SUNDRY NOTICES AND REPORTS ON WELLS
Do not use this form for proposals to drill or to re-enter an abandoned well. Use form 3160-3 (APD) for such proposals.

8. Well Name and No.
GISSLER B 10

Burnett Oil would like to plug and abandon the Gissler B 10 well using the following procedure:

WELL COMPLETION SKETCH

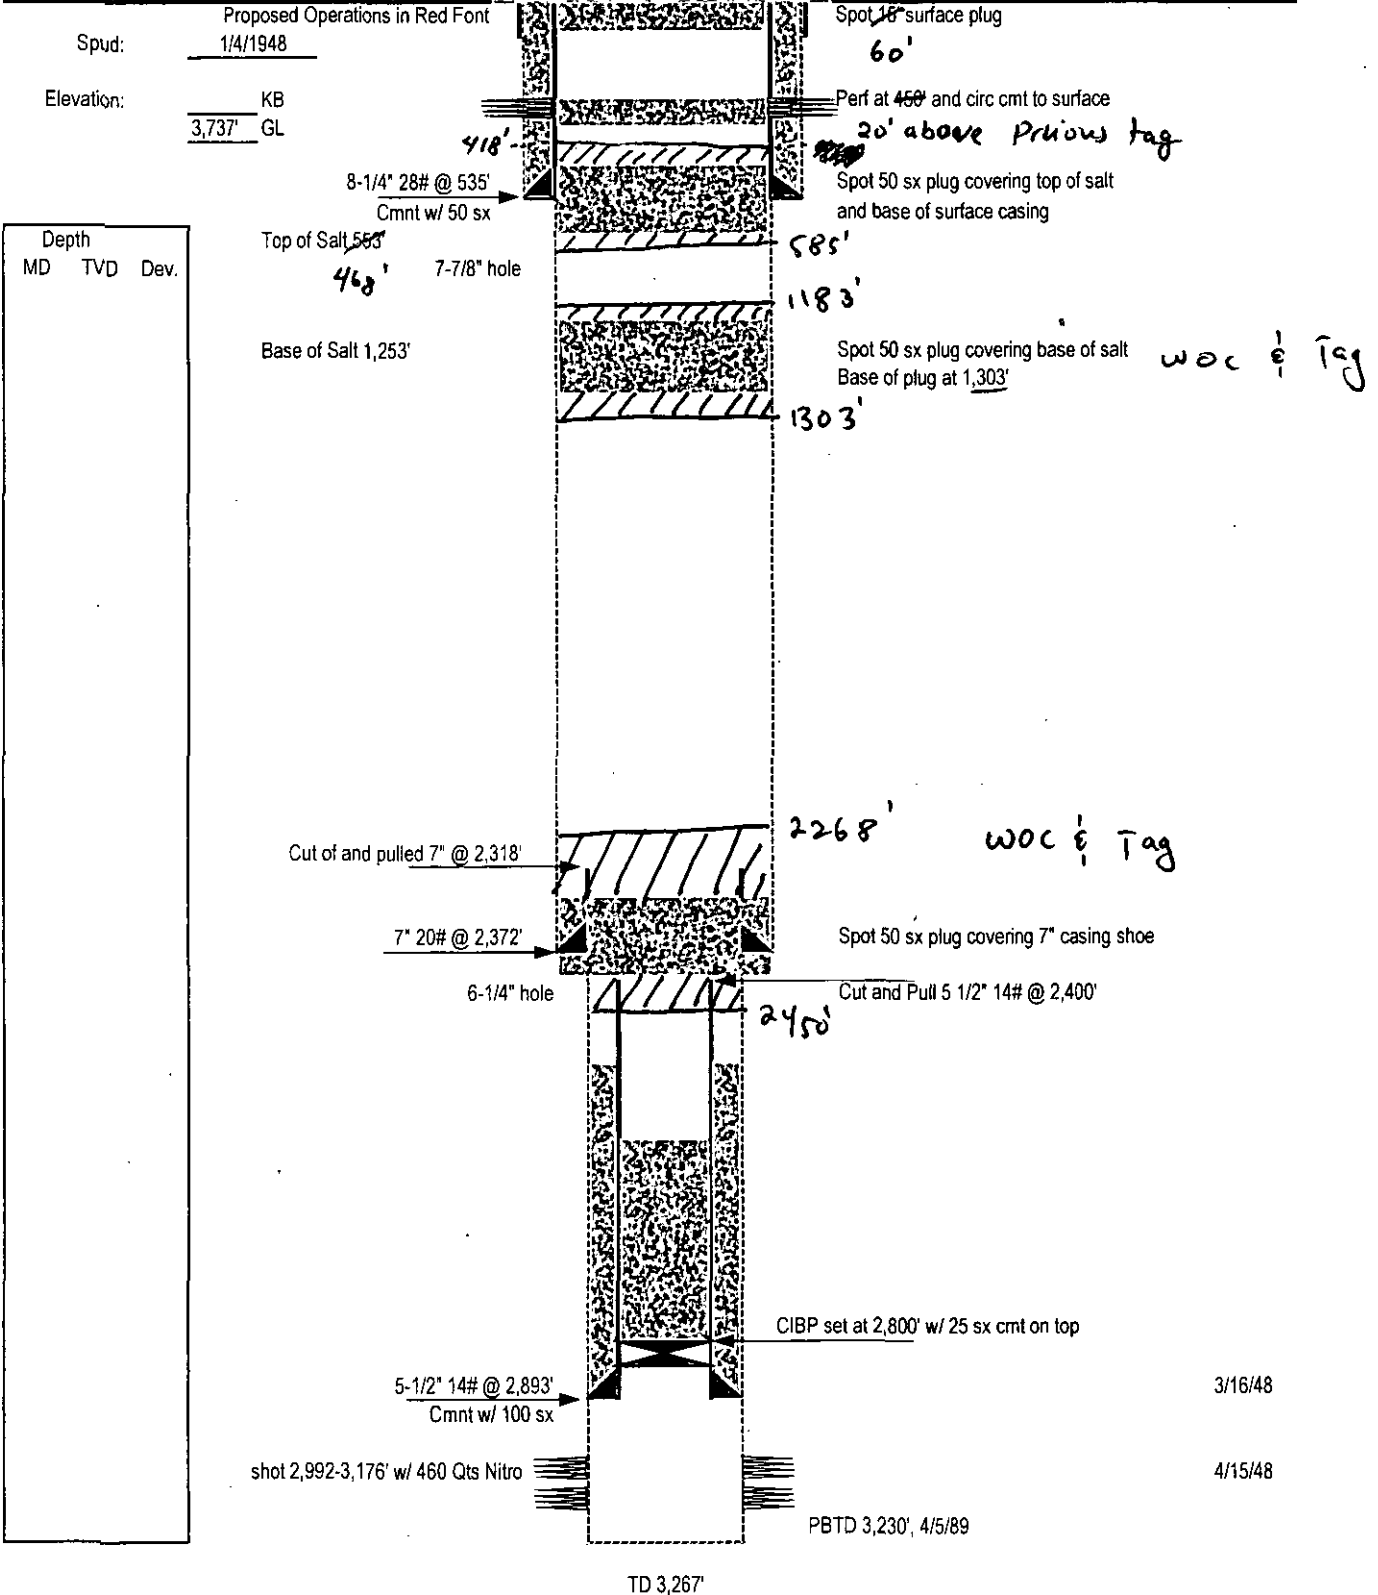
9. Spot 50 sx plug covering ~~top of salt and~~ base of surface casing at 540? (~~base of plug at 603?~~) WOC and tag cmt *(from 585' - 418')*
10. Perf surface casing at 450? and circulate cmt to surface
11. Spot 18? surface plug *20' above Previous tag*
12. LD tbg *60'*
13. RDMO WOR
14. Dig out and cut off wellhead, weld steel plate, and install dry hole marker
